1916 EASTLAKE AVENUE E
RECOMMENDATION MEETING
NOVEMBER 15 2017
SDCI #3023368

EDG SUMMARY & RESPONSE

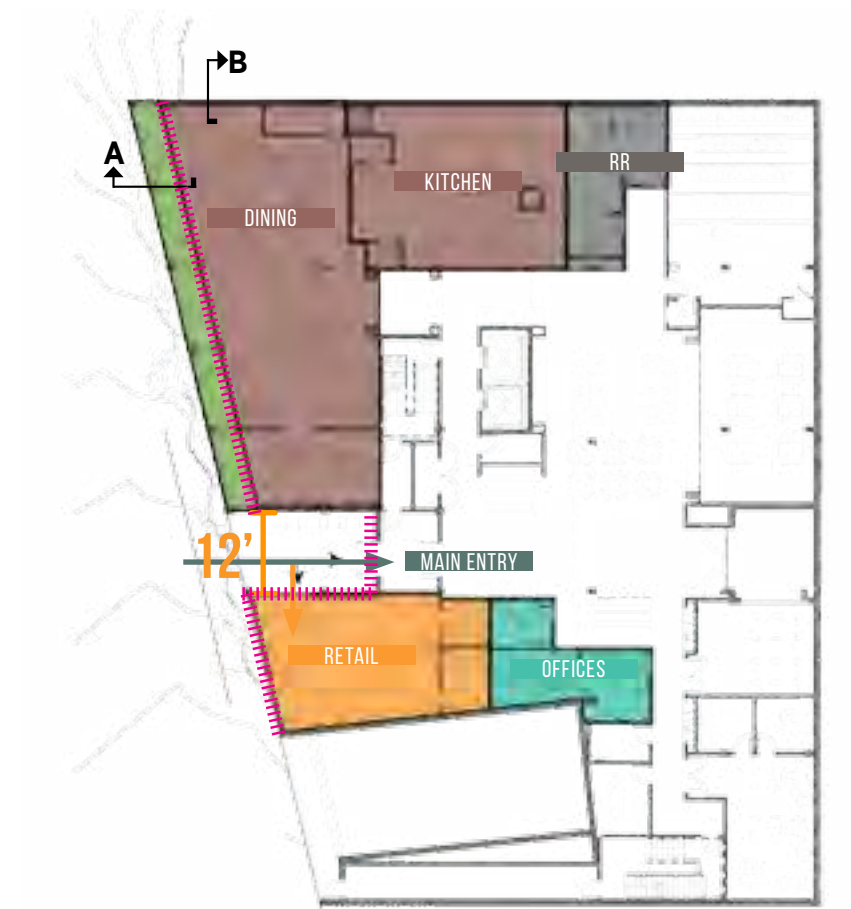
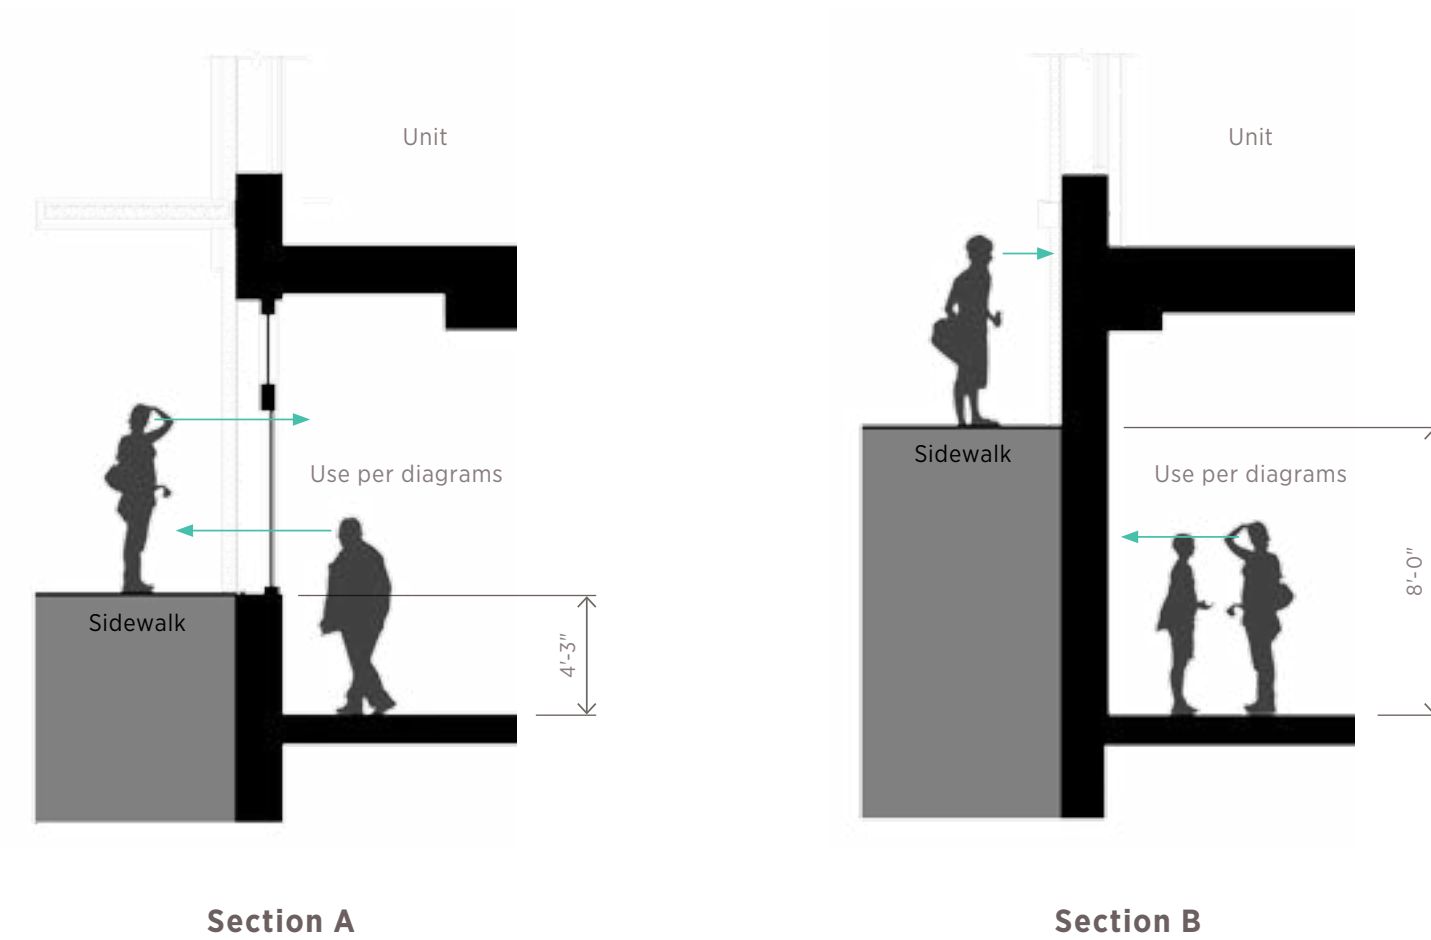
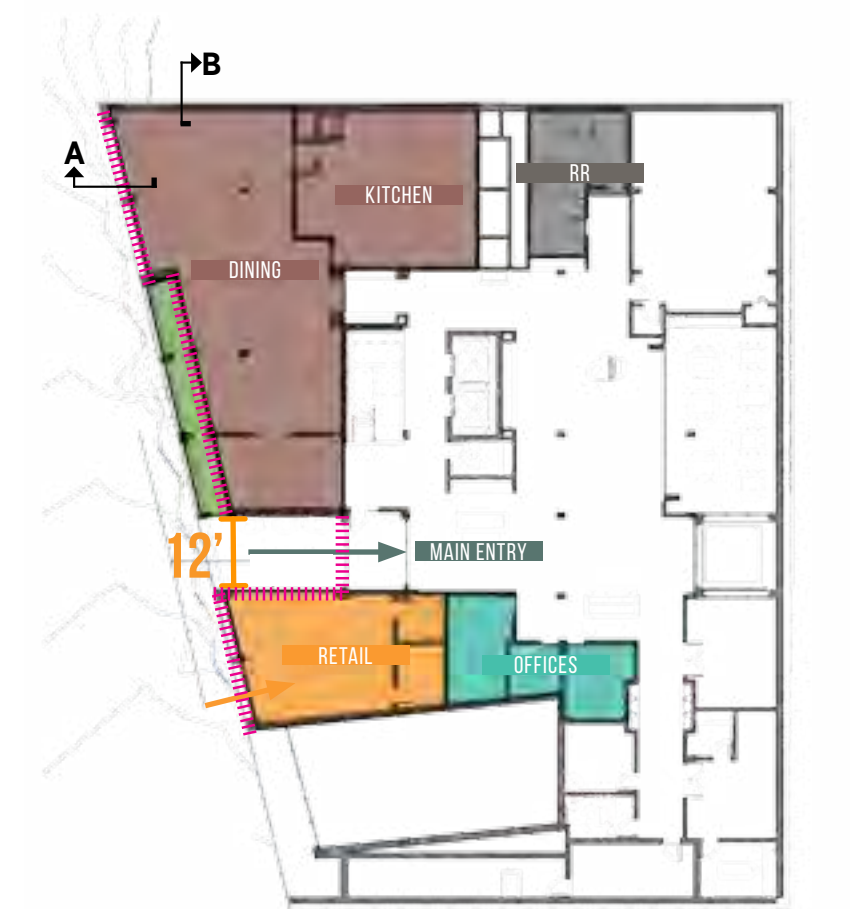
The Board expressed concern regarding the location of ground level uses. The Board felt the retail space was hidden at the center of the site, and the dining space at the corner would be less engaging and not activated throughout large portions of the day. The Board felt strongly that the retail space should be relocated to the corner of Newton and Eastlake Avenue E to better integrate with the neighborhood (PL3-C, DC1-A).

- Stormwater planter extends length of dining room edge at Eastlake Ave E sidewalk.
- Retail and residential share entry court including outdoor seating.

- Locating the retail at the corner is traditional urban design in most cases, however significant differences in finish floor and adjacent sidewalk (see Section A & B) grades on this site decrease effectiveness of this scheme to strengthen the corner on this site.
- Shifting ground floor uses moves retail and residential entries 80' apart, decreases size of entry court, eliminates retail outdoor seating, and removes stormwater planters which must be converted to a ramp for public access to retail.
- The dining room is a very active amenity space serving 300+ meals per day from 7am to 7pm, making this space at least as active as any other restaurant along Eastlake.

- Eliminating the stormwater planter and bumping dining out creates a more direct connection between dining and pedestrians.
- Locating retail at south side of entry court creates active, shared entry court for the public and residents and closer proximity to the nearest bus stop.

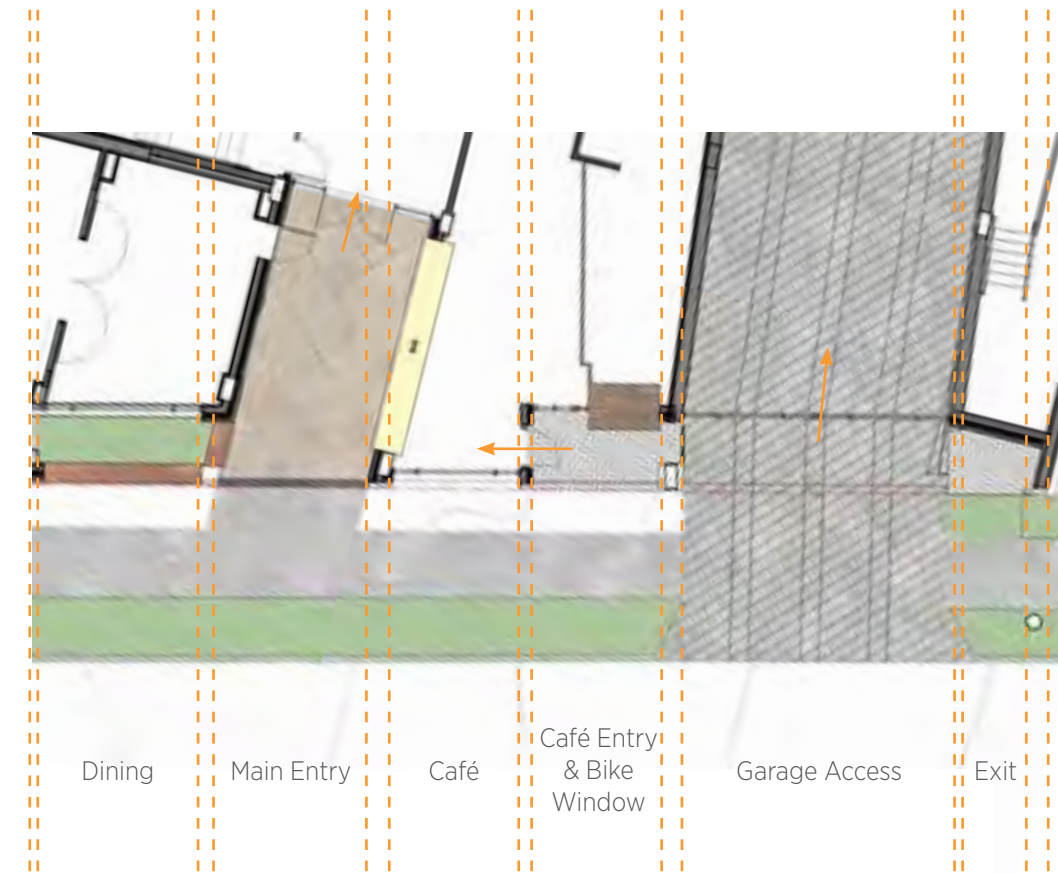
At the Recommendation phase, the Board would like more detail demonstrating how the garage access is designed to minimize the impact to the pedestrian streetscape (DC1-B).

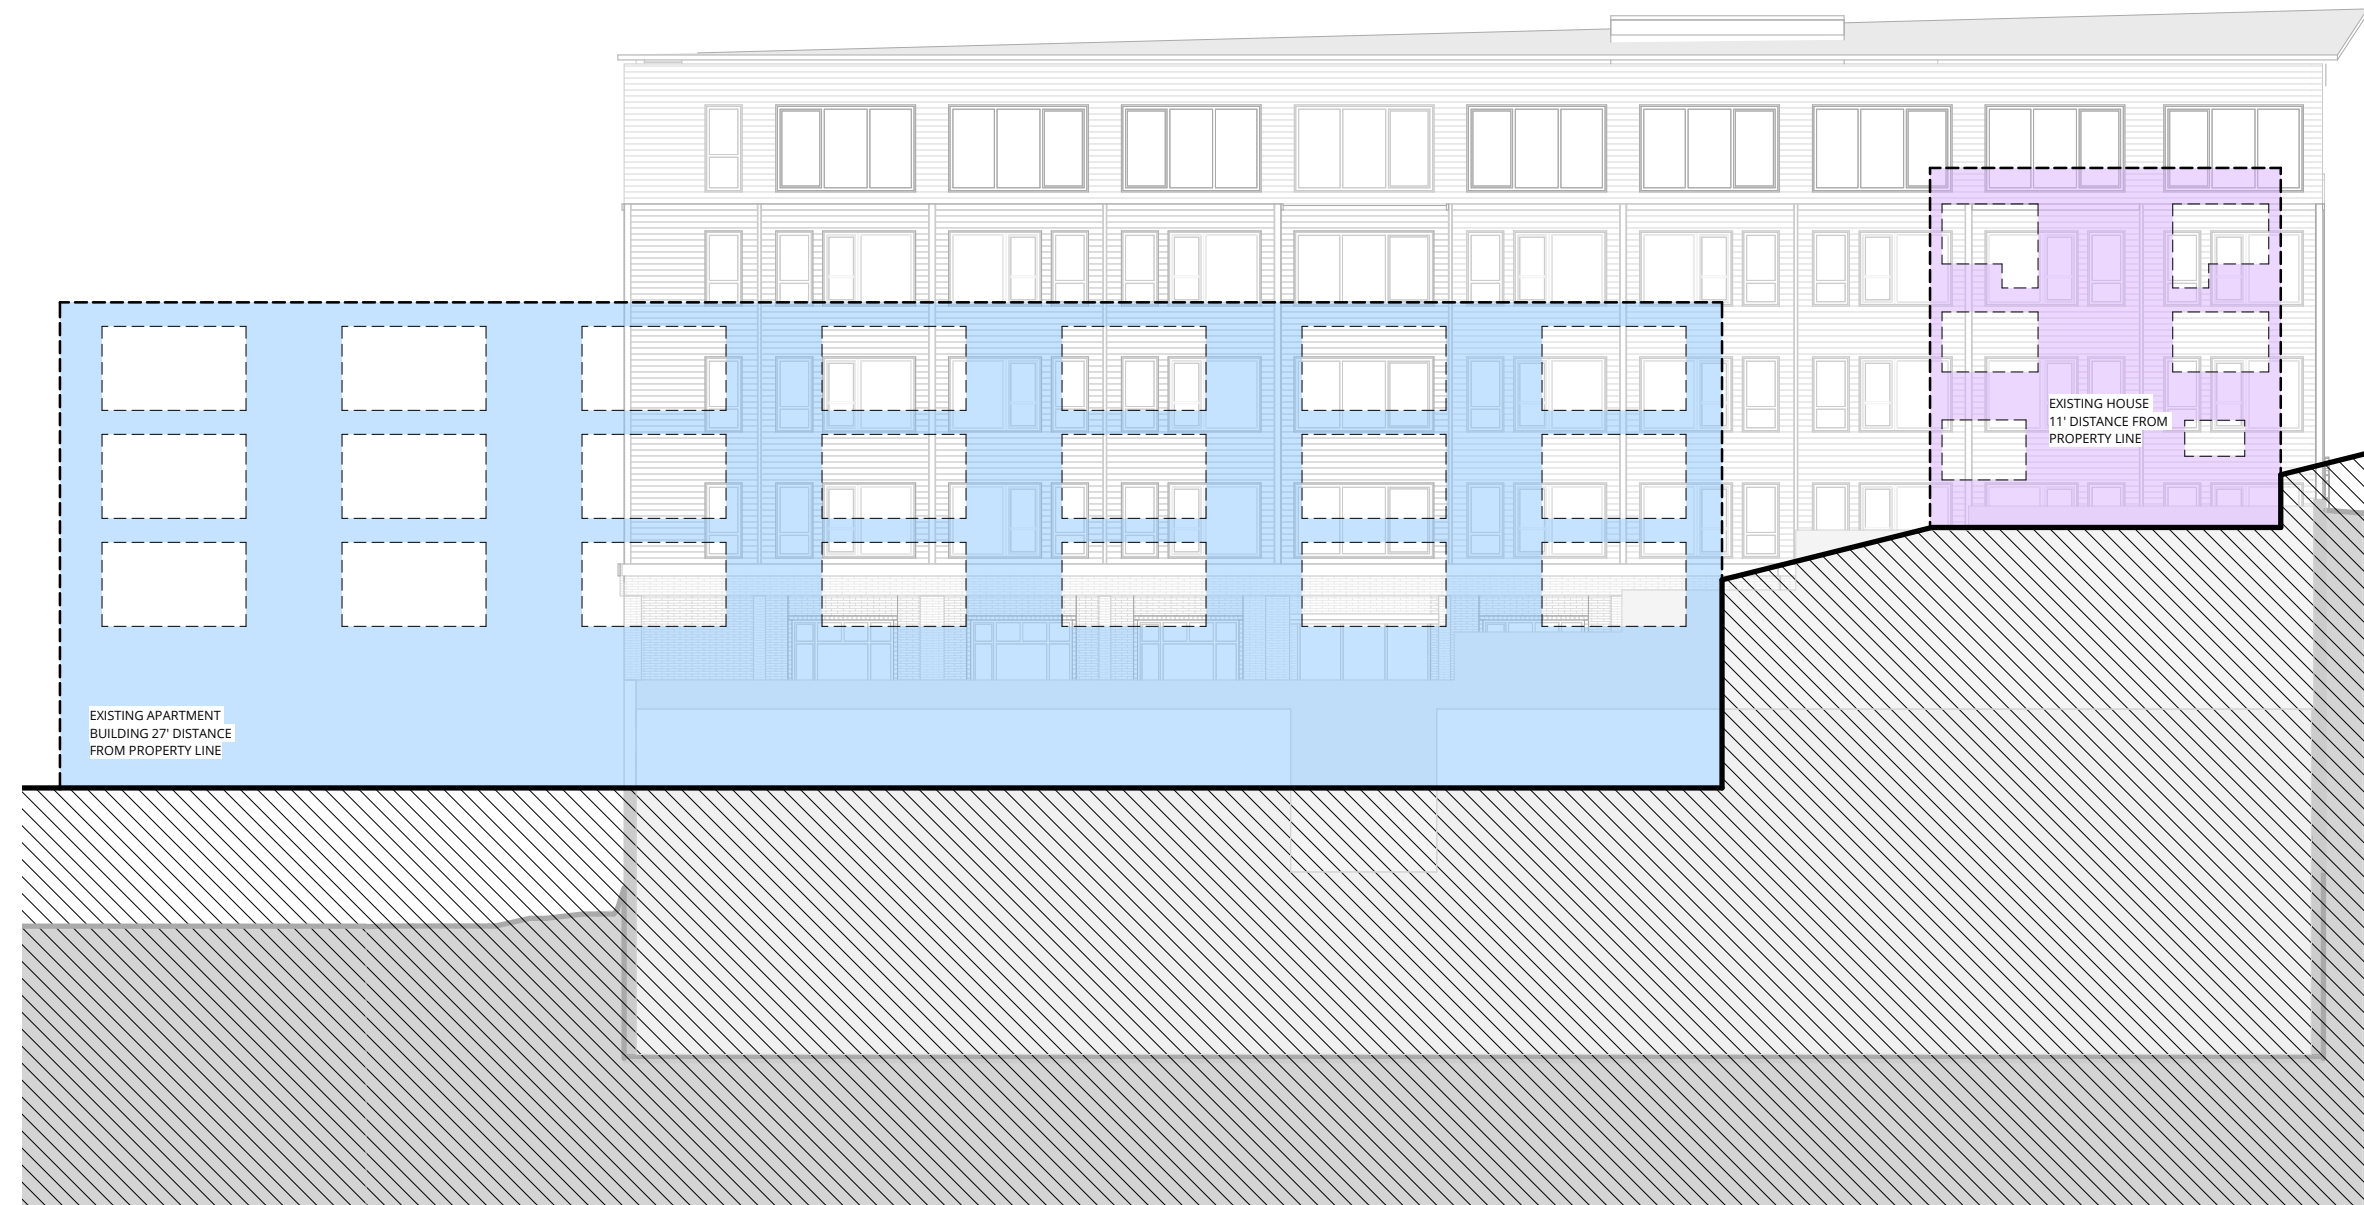
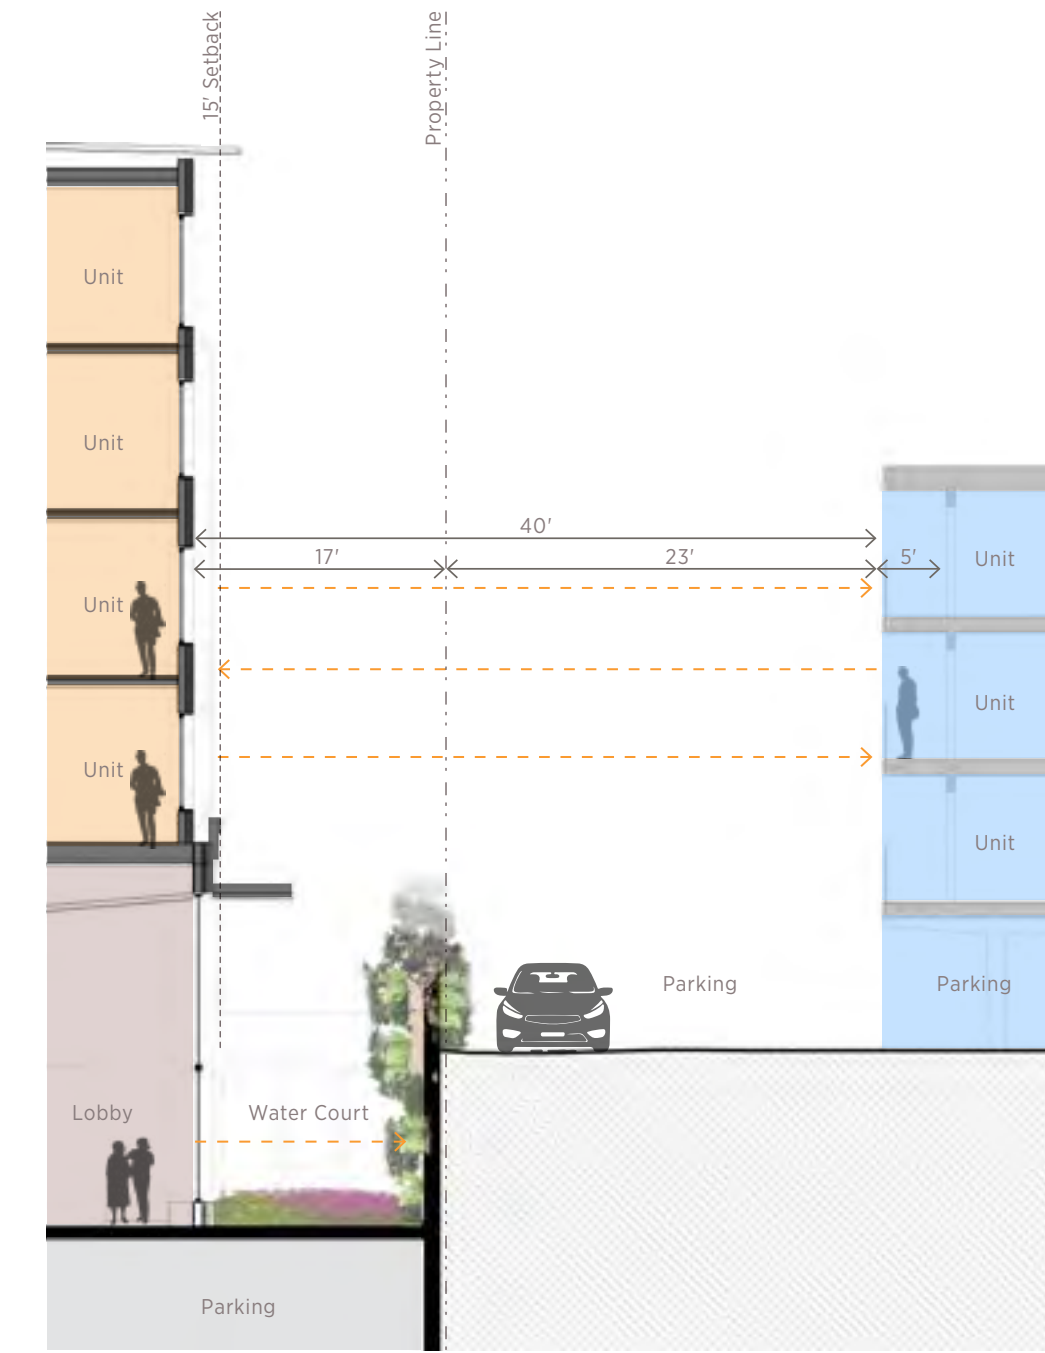
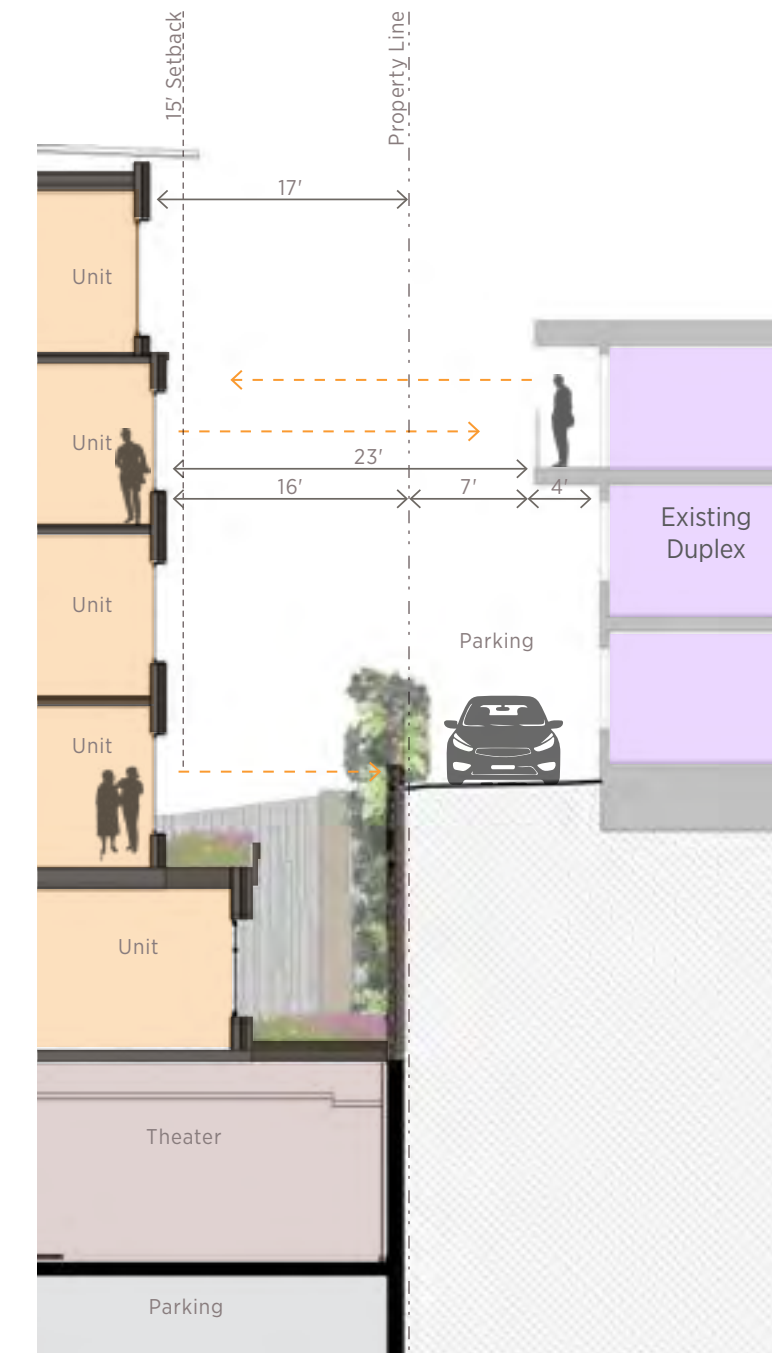
At the Recommendation phase, the Board noted public comment and requested additional detail demonstrating how the east facade has been designed to minimize privacy impacts to adjacent residential units (CS2-D5).
